SUBJECT: Redline Pages to the Periodic Report 5 for the Upper Three Runs Integrator Operable Unit (IOU) (U) (SRNS-RP-2017-00548, Revision 1, July 2018) and Savannah River Site's Responses to Regulatory Comments on the Revision 0 Document, CERCLIS Number: 70

**Final SRS Responses to EPA Comments on
Periodic Report 5 for the Upper Three Runs IOU,
SRNS-RP-2017-00548, Revision 0, February 2018, CERCLIS Number: 70
Page 1 of 9**

Final SRS Responses to South Carolina
Department of Health and Environmental Control Comments on:
Periodic Report 5 for the Upper Three Runs Integrator Operable Unit (IOU) (U),
CERCLIS Number: 70 (SRNS-RP-2017-00548, Revision 0, February 2018)
Page 1 of 3

Figure 1-56. Upper Three Runs IOU Conceptual Site Model

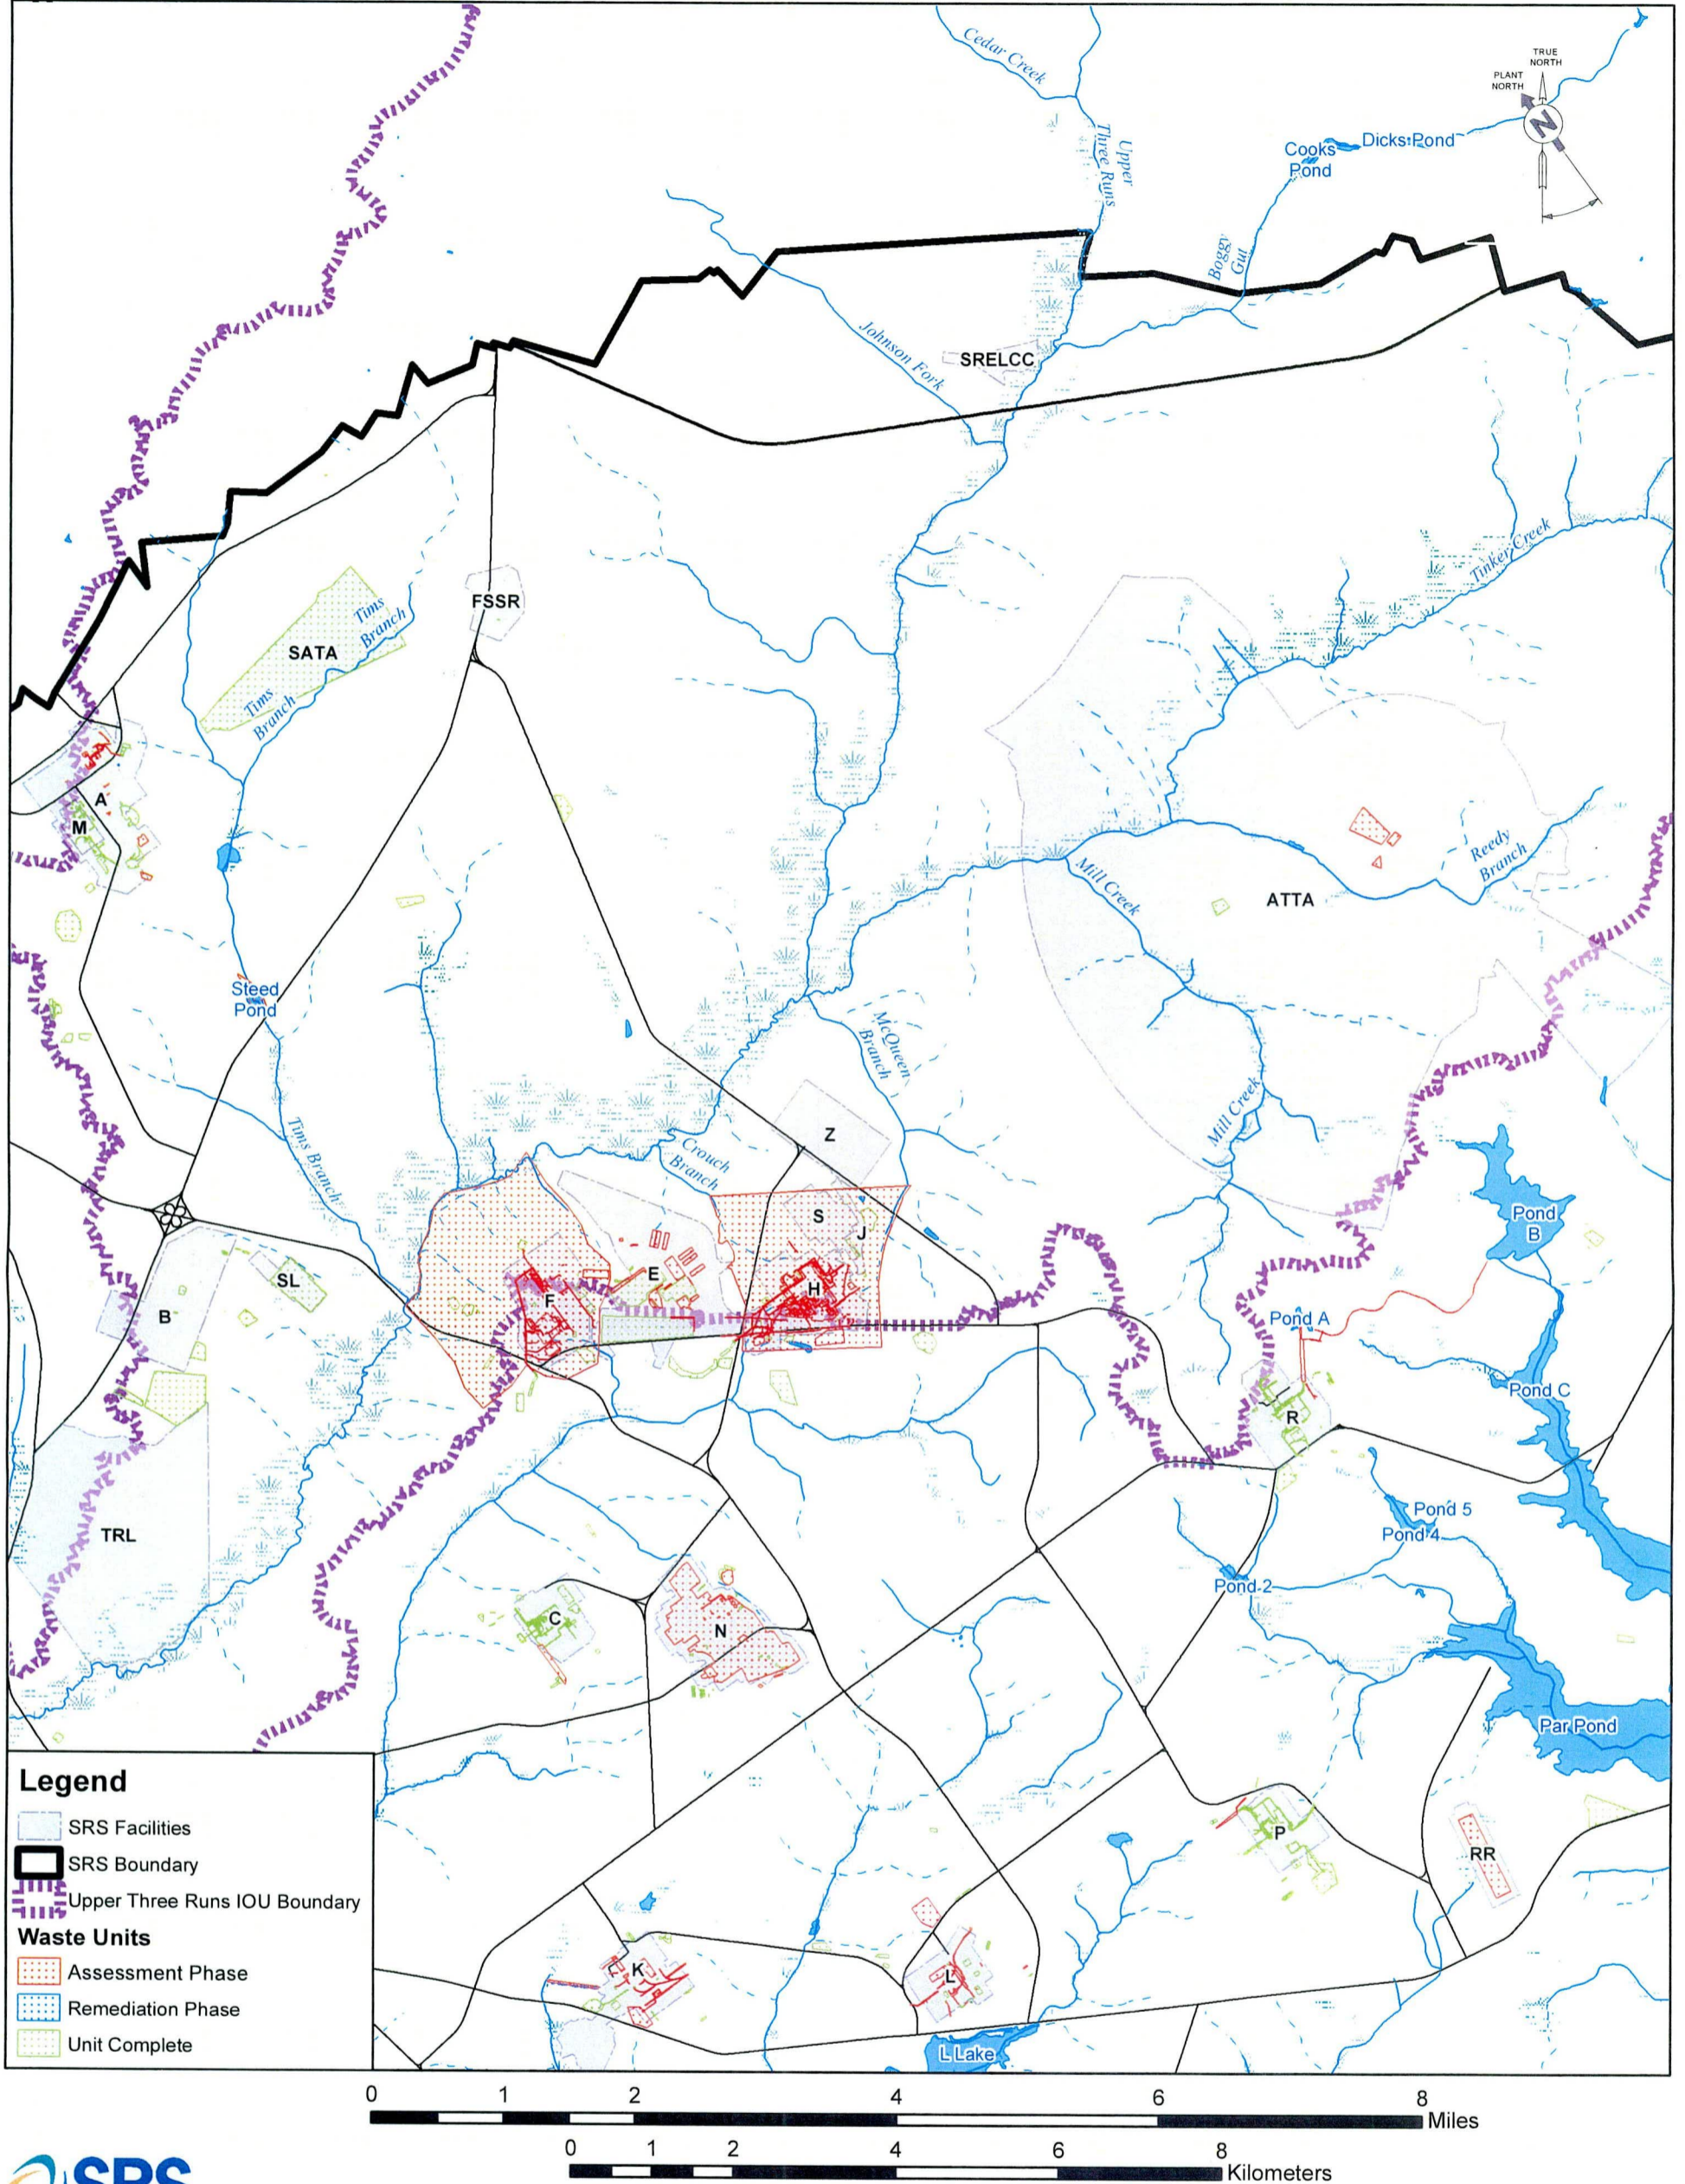
2. Figure 1-5, Upper Three Runs IOU Conceptual Site Model, page 1-35. There are a few discrepancies between the CSM and Table 1-1 regarding the potential for listed OUs to impact groundwater and/or surface water at the UTR IOU. The CSM lists the following OUs as impacting both surface water and groundwater, yet Table 1-1 lists only the potential for groundwater impact: 141, 142 and 591. Also, 429 is listed as potentially impacting only groundwater; yet, Table 1-1 lists the potential for impact to both groundwater and surface water. Please revise.

3. Figure 1-5. Upper Three Runs IOU Conceptual Site Model, page 1-35. Please add unit ID #456, Steed Pond, G-Area, to the UTR IOU CSM.

Response: Agree. To address this comment, the CSM, relabeled as Figure 1-6, will be revised as follows.

- a. Unit F-141 (F-Area Inactive Process Sewer Lines) will be moved to the preceding F Area box for potential impact to Groundwater only.
- b. Units H-142 (H Area Inactive Process Sewer Lines) and H-591 (H Area Process Sewer Lines as Abandoned) will be inserted into the bottom H Area box that already contains Unit 275 associated with the H Area Tank Farm Area Operable

Unit. Unit H-142 and H-591 will be denoted as associated with H Area Operable Unit (581) for potential impact to GW only.

c. Unit F-429 will be moved to the last F Area box for potential impact to both Groundwater and Surface Water.

Response: Clarification. Unit 456 is appropriately included under Contaminant Migration Pathways as Tim's Branch, Steed Pond (456) in the revised Figure 1-6.

Figure 1-3: Operable Units Associated with the UTR IOU

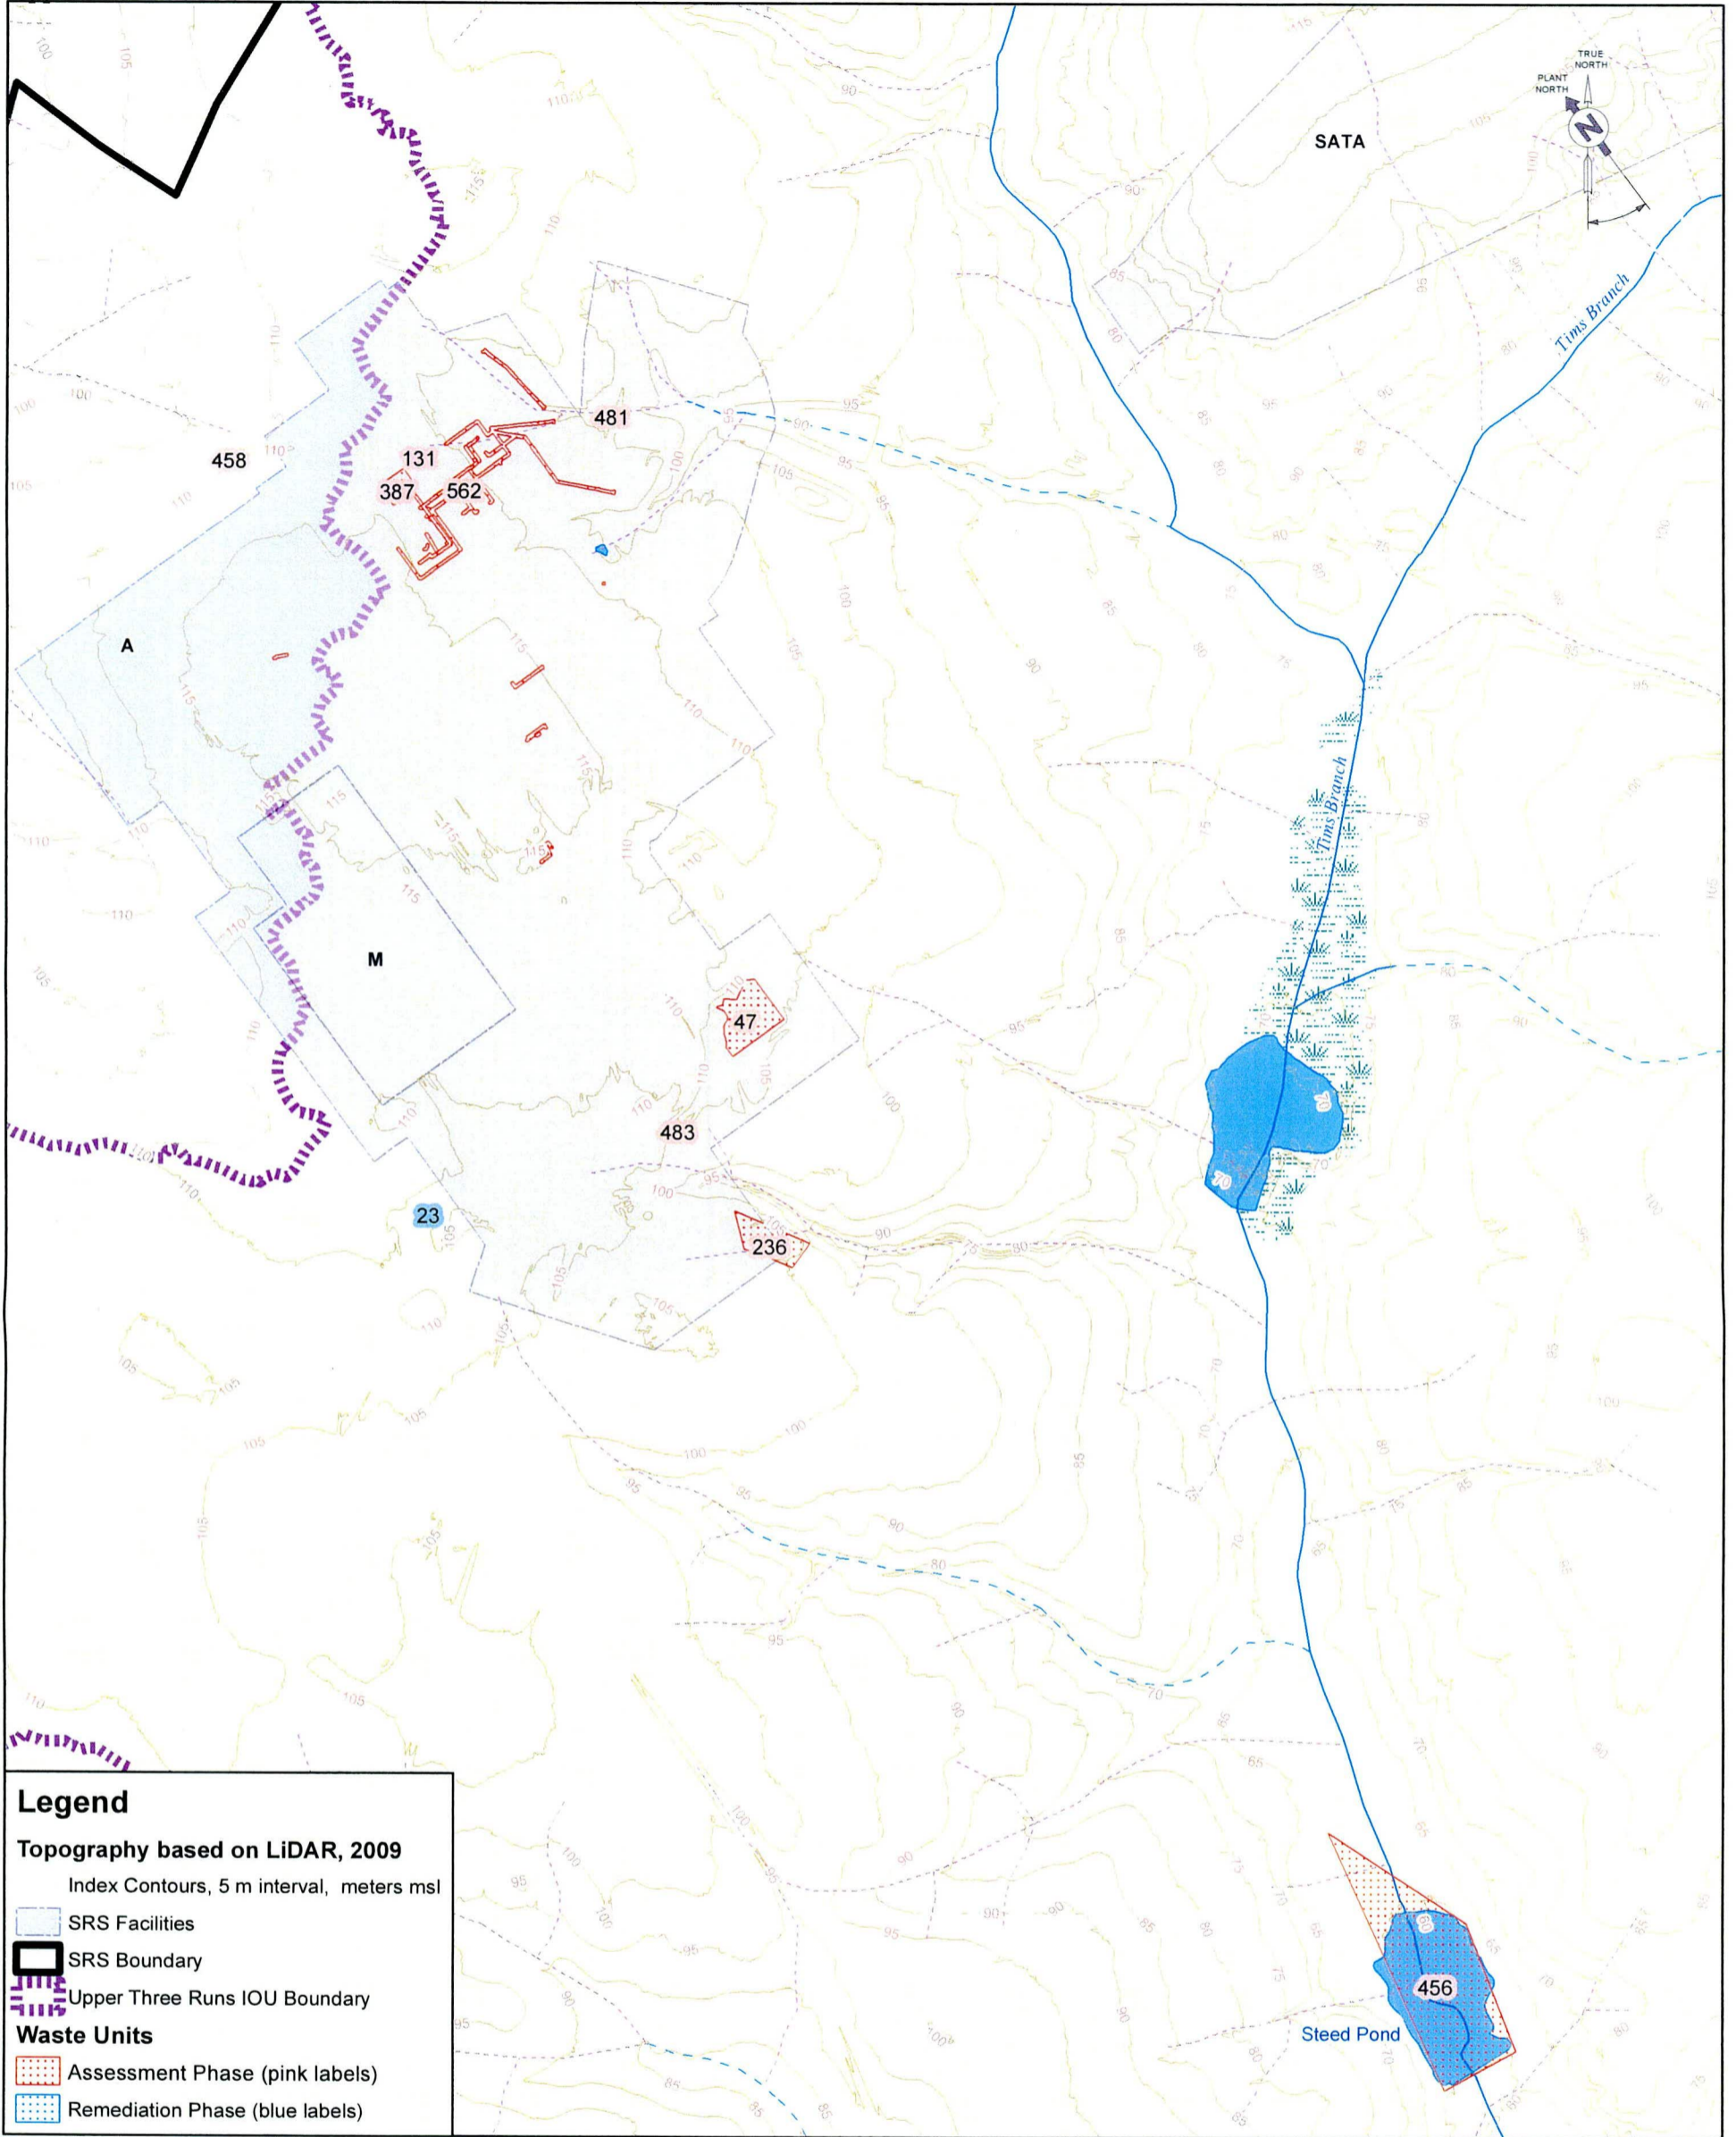
1. There are several discrepancies between the figures showing all of the operable units (OU) for each area in the UTR IOU (all of the figures associated with Figures 1-3 and 1-4) and Table 1-1, which lists all of the OUs for each area. Specifically, the following OUs are listed in Table 1-1 but are not shown in figures corresponding with their respective areas:
 - a. A/M Area (Figures 1-3a and 1-4a): 24, 44, 133, 134, 195, 384, 400, 406, 409, 410, 419, 420, 436, 446, 449, 451, 480, 484 and 521
 - b. B Area (Figures 1-3b and 1-4b): 530
 - c. F and E Areas (Figures 1-3c and 1-4c): 35, 199, 200, 227, 263, 284, 308, 368, 372, 399, 414, 416, 422, 424, 435, 438, 445, 485 and 490
 - d. H, S and Z Areas (Figures 1-3d and 1-4d): 260, 264, 295, 364, 383, 403, 412, 423, 433 and 512
 - e. G Area (Figures 1-3f and 1-4f): 38, 40, 140, 174, 186, 213, 333, 463, 541 and 568

These figures should be revised to include all applicable OUs that are listed in Table 1-1, including insets showing expanded high population areas if necessary. The figures showing G Area OUs can be expanded and modified to show only the G Area OUs.

Additionally, the following OUs were depicted inside the UTR IOU footprint on the following figures but were not included in Table 1-1:

- a. Figure 1-3a: 12, 100, 189, 197, 397 and 486
- b. Figure 1-3c: 592
- c. Figure 1-3d: 285

Please correct these discrepancies.

Response: Agree with clarification. To address this comment, a new general figure (Figure 1-3) will be added that shows all units listed in Table 1-1 for all three phases (Assessment, Remediation, and Complete) to orient readers to the location of units in the UTR watershed/adjacent watersheds. Unit IDs will not be included on Figure 1-3 due to the scale of the figure and to provide a correlation to the conceptual site model that shows only units in the Assessment and Remediation phase. The Rev. 0 Figures 1-3a to 3f have been replaced with Figures 1-4a to 1-4d focusing only on the areas with Assessment and Remediation units to allow unit ID numbers to be visible and to provide a correlation to the conceptual site model that shows only units in the Assessment and Remediation phase. There are fewer figures since Complete units are not shown on the detailed figures. The areas shown in the revised detailed figures include A/M-Area (Figure 1-4a), F and E Areas (Figure 1-4b), H, S, and Z-Areas (Figure 1-4c), and R Area (Figure 1-4d) for topography incorporating scale appropriate G Area units. Similar figures (Figures 1-5a to 1-5d) will

show the groundwater plumes and potentiometric contours. Figure 1-5a includes both A/M-Area and B-Area to follow the extent of the plumes. Some units do not have a georeferenced location and are not on the figures. Table 1-1 will include a note for those units. Unit 592 will be added to Table 1-1. Please see the attached revised figures and Table 1-1.
